September 21, 2023

Project: Madrona Crest Lot 9, 3605 86th Ave SE, Permit # 2306-185

I have reviewed the SDCI review correction notice and have the following responses to the Structural items. Please note that the numbers of my responses correspond to the numbers on the correction sheet.

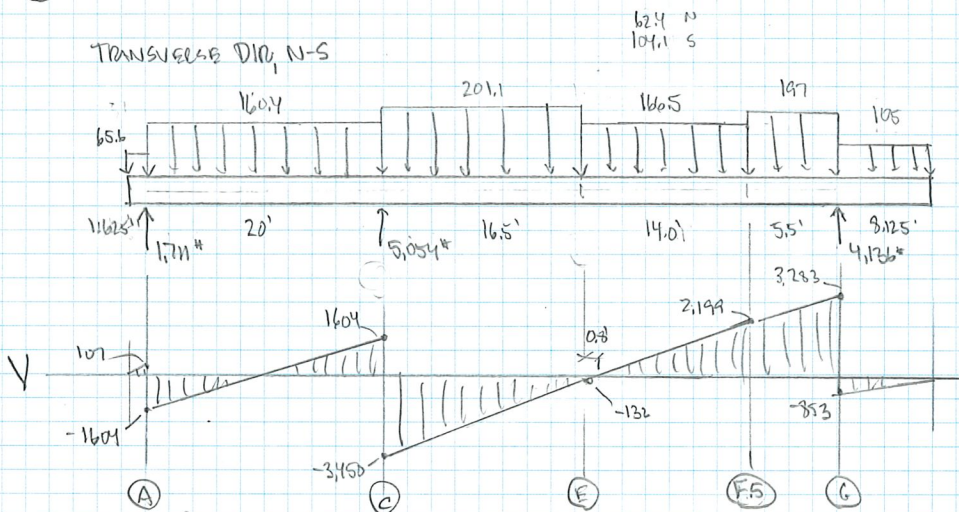
6. Detail 1/S3.1 is cut at porch roofs on Sheet S2.1. Verify uplift connection capacity.

Response: See the attached calculations. The designed connection is within 6% of allowable steel stresses so it is acceptable in my professional opinion.

① $W = 414^{\#}/\text{screw}$

$Z = 136^{\#}/\text{screw} \rightarrow \text{SEE ATTACHED CALC.}$

UPPER & RAFTERS AT SOUTH COVERED ROOF (WORST CASE) = $273^{\#} \leq (2) 136^{\#}$ SEE ATTACHED CALC.

$M = 273^{\#} (1^{\#} \cdot 0.125^{\#}) = 239 \text{ in}\cdot\text{ft}$

$S = \frac{239}{0.16(36,000)} = 0.011 \text{ in}^3$; $S_{1/8^{\#} \times 2^{\#} \times 1/2^{\#} \times 1/4^{\#} R} = \frac{4(0.125)^2}{6} = 0.0104 \text{ in}^3 \therefore \text{WITHIN } 6\% \therefore \text{OK}$

③ UPPER FLOOR DIAPHRAGM SHEAR DIAGRAMS; $F_D = 15,573^{\#} \times 0.7 = 10,901^{\#} (\text{ASD})$ 3,273 ER

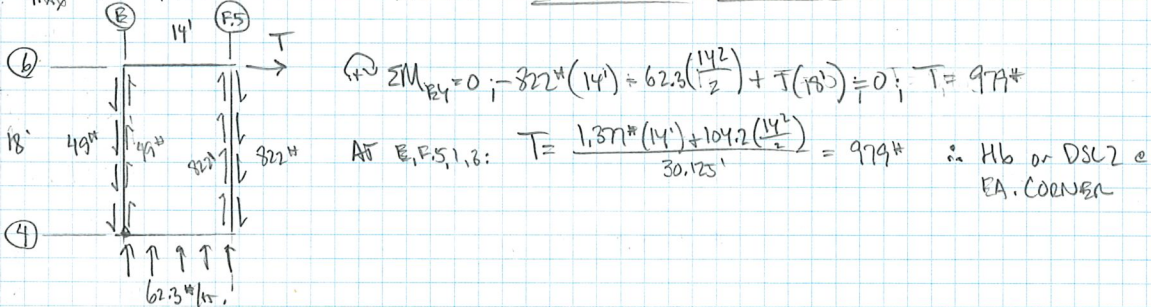
23. Provide an evaluation of horizontal diaphragms to show adequacy per IBC 2305.1, SDPWS 4.2.1, and ASCE 12.10.1. Diaphragms must be designed for both the shear and bending stresses resulting from design forces. At diaphragm discontinuities, such as openings and re-entrant corners, the design must assure that the dissipation or transfer of edge (chord) forces combined with other forces in the diaphragm is within shear and tension capacity of the diaphragm.

Response: See the attached calculations for calculation of diaphragm shears and force transfer around the opening. Connectors have been added to the corners of the opening of the diaphragm opening, see Sheet S2.1.

$V_{max} = 3,450^{\#} / 47.125^{\#} = 73.2^{\#}/\text{ft} \leq 140^{\#}/\text{ft} \therefore \text{UNBLOCKED DIAPHRAGM OK}$

Upper Floor Framing, 4 - Joist
1 piece(s) 11 7/8" TJI @ 210 @ 16" OC

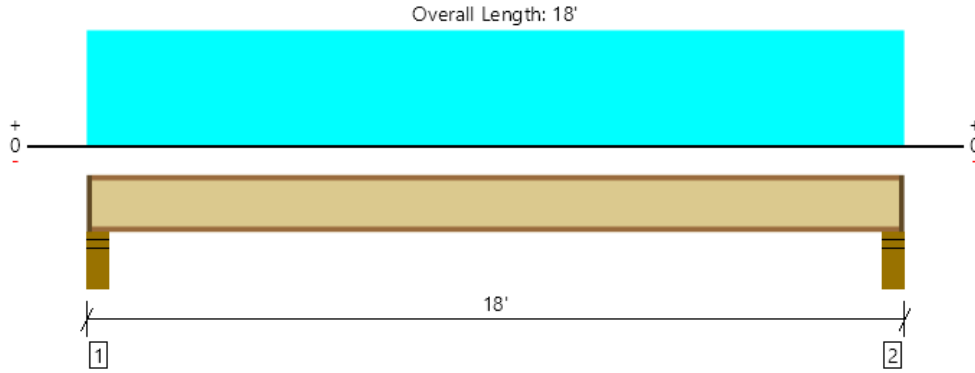
9. Only sleeping areas can be designed with a 30 psf live load per IBC Table 1607.1, all other residential areas must use a live load of 40 psf. The typical upper floor TJI joist calculations only assume a 30 psf live load. It appears additional evaluation is needed for areas other than sleeping areas. See page 12 of the calculations. Verify other locations considered a live load of 40 psf at non-sleeping areas.

Response: See the attached calculations demonstrating that the joists can support 40 psf for the entire span if required.
